SUBJECT: ISSUANCE OF AMENDMENT FOR NINE MILE POINT NUCLEAR STATION, UNIT 2  
(TAC NO. M95405)

AMENDMENT NO. 77 TO FACILITY OPERATING LICENSE NO. NPF-69-NINE MILE POINT  
UNIT 2

SAFETY EVALUATION BY THE OFFICE OF NUCLEAR REACTOR REGULATION

RELATED TO AMENDMENT NO. 77 TO FACILITY OPERATING LICENSE NO. NPF-69

FIGURE 3.3.2-1 Allowable and Trip Setpoint Values for the Main Steam Line Tunnel Lead Enclosure

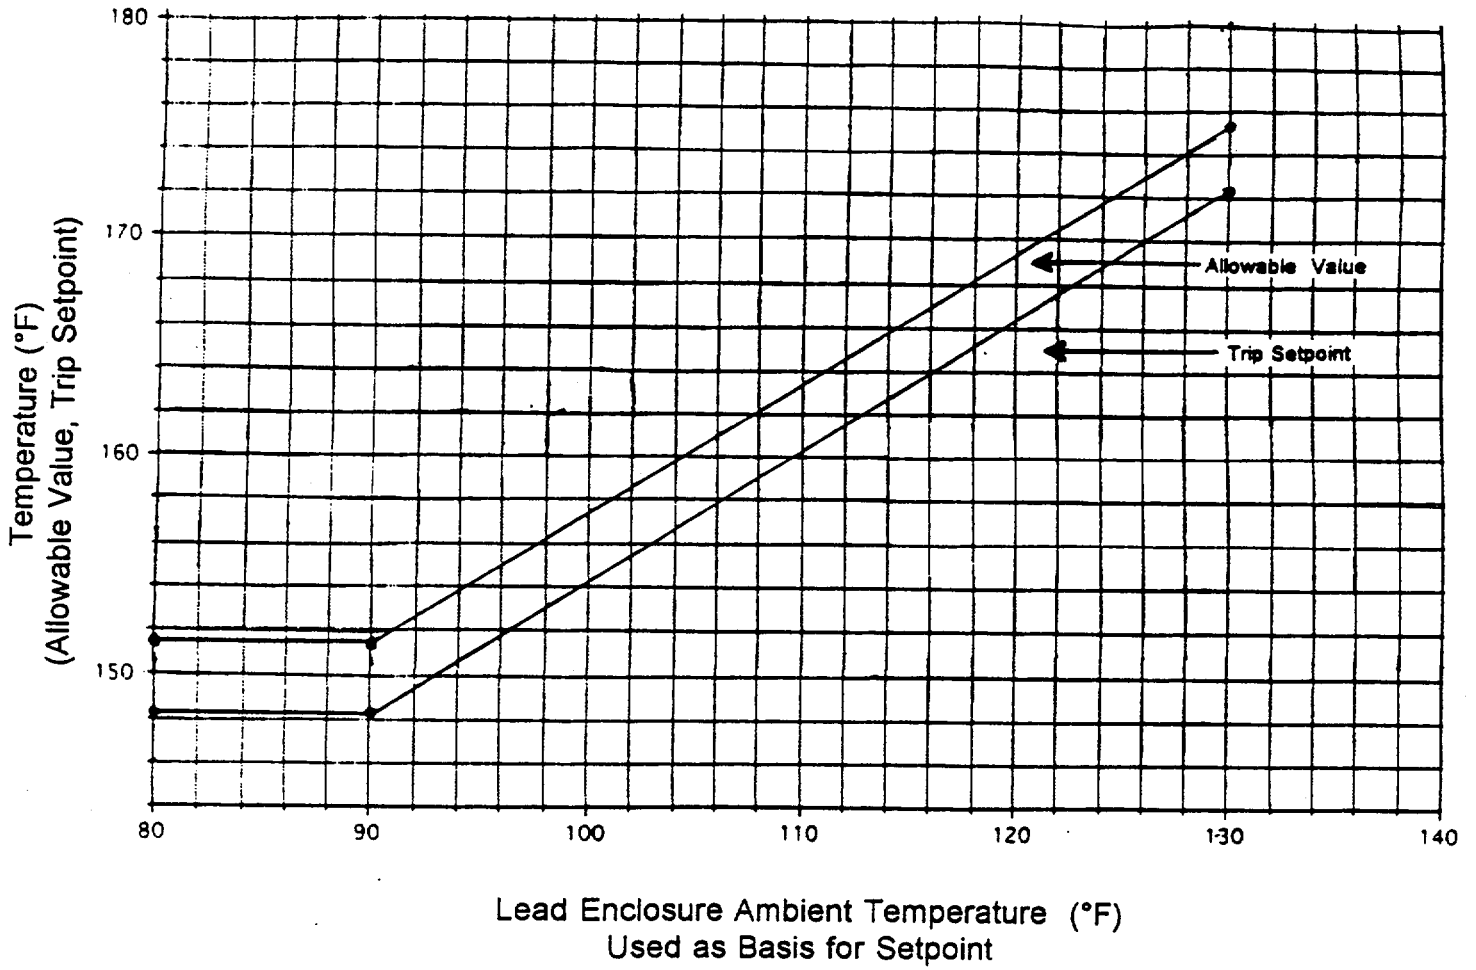
The amendment revises TS 3/4.3.2, "Isolation Actuation Instrumentation," to establish a range of allowable values and trip setpoints for high temperatures in the Main Steam Line Tunnel Lead Enclosure.

- \*\*\*** The trip setpoint and allowable value for a channel may be established based on Figure 3.3.2-1, if:
- a. the actual ambient temperature reading for all operable channels in the Lead Enclosure area are equal to or greater than the ambient temperature used as the basis for the setpoint, and

- b. the absence of steam leaks in the Main Steam Line Tunnel Lead Enclosure area is verified by visual inspection prior to increasing a channel setpoint, and

- c. a surveillance is implemented in accordance with Note "d" of Table 4.3.2.1-1.

Since the temperature in the MSLTLE resulting from a postulated steam leak depends on the initial ambient temperature in the area, the licensee has calculated the acceptable trip setpoint and allowable temperature for MSLTLE ambient temperatures from 80 °F to 130 °F as shown on TS Figure 3.3.2-1. The methodology utilized to determine the allowable values and setpoints is in accordance with Regulatory Guide 1.105, "Instrument Setpoints for Safety-Related Systems," Revision 2, February 1986, and Instrument Society of America Standard ISA-S67.04, "Setpoints for Nuclear Safety Related Instrumentation Used in Nuclear Power Plants," 1982.

The licensee proposes to change the instrumentation setpoint and allowable value for high temperature based upon the MSLTLE ambient temperatures of TS Figure 3.3.2-1 subject to the following three conditions:

Since the calculated values used in Figure 3.3.2-1 are based upon normal operating conditions, the absence of any steam leaks in the MSLTLE needs to be verified prior to increasing the setpoint of any instrument channel. The NRC staff finds that visual inspection in accordance with item b above is a sufficient requirement to this end. The NRC staff also finds that the surveillance required by item c above will provide adequate verification of the continued validity of a setpoint established using Figure 3.3.2-1.

In summary, from its review of the licensee's request to establish and use a range of allowable values and trip setpoints for high temperature in the MSLTLE, the NRC staff concludes that the licensee has provided adequate TS requirements to assure that a 25 gpm steam leak will be detected and the MSIVs will be closed as necessary to isolate the leak. This TS change will also provide increased assurance that unwarranted MSIV closures and reactor scrams at full power will not occur due to high normal ambient air conditions in the absence of a steam leak. The NRC staff, therefore, finds the proposed TS changes acceptable.
